Access Compliance Report Public Rights-of-Way (Curb Ramps)

Intersection ID: 47116 Main Street: MCKEE_FOREST_CT Cross Street: CARPENTER_CABIN_DR Location: N

ADA ID: 4CB08E8B9DEC Ramp Type: Perp Initial Pass/Fail: Fail Overall Compliance: No Severity Score: 1.25

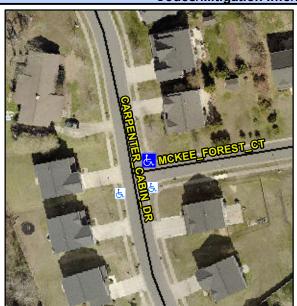
COCIDIO COIGNION	
Possible Solutions:	Com
Remove & Replace Entire Ramp.	N/A
•	Yes
	N/A
	N/A
	N/A
	N/A
Surveyor Notes:	N/A
N/A	N/A
	N/A
	N/A
	N/A
PROW/ADA:	N/A
Not Found, R304.5.3	N/A
·	N/A
	N/A
	N/A

Field Measurements/Component Compliance							
Comp	liance Description	Data	Comp	liance	Description	Data	
N/A	Ramp Length (in)	69.0	Yes	Ramp	Slope (%)	7.3	
Yes	Ramp Width (in)	48.0	No	Ramp	XSlope (%)	2.7	
N/A	Flare Type LT	N/A	N/A	Flare	Type RT	N/A	
N/A	Flare Slope LT (%)	N/A	N/A	Flare	Slope RT (%)	N/A	
N/A	Flare Traversable LT?	N/A	N/A	Flare	Traversable RT?	N/A	
N/A	Landing Length (in)	N/A	N/A	DWS	Provided?	N/A	
N/A	Landing Width (in)	N/A	N/A	DWS	Contrast?	N/A	
N/A	Landing Slope (%)	N/A	N/A	DWS	Length (in)	N/A	
N/A	Landing X Slope (%)	N/A	N/A	DWS	Full Width?	N/A	
N/A	Landing Curb? (Y/N)	N/A	N/A	DWS	Offset (in)	N/A	
N/A	Shared Landing?	N/A					
N/A	Gutter Ponding?	N/A	N/A	Gutte	Slope (%)	N/A	
N/A	Gutter Lip Ht (in)	N/A	N/A	Gutte	X Slope (%)	N/A	
N/A	Painted X Walk1?	No	N/A	Painte	ed X Walk2?	N/A	
	X Walk 1 Direction	To S		X Wal	k 2 Direction	N/A	
N/A	X Walk 1 Width (in)	N/A	N/A	X Wal	k 2 Width (in)	N/A	
	X Walk 1 Slope (%)	3.8		X Wal	k 2 Slope (%)	N/A
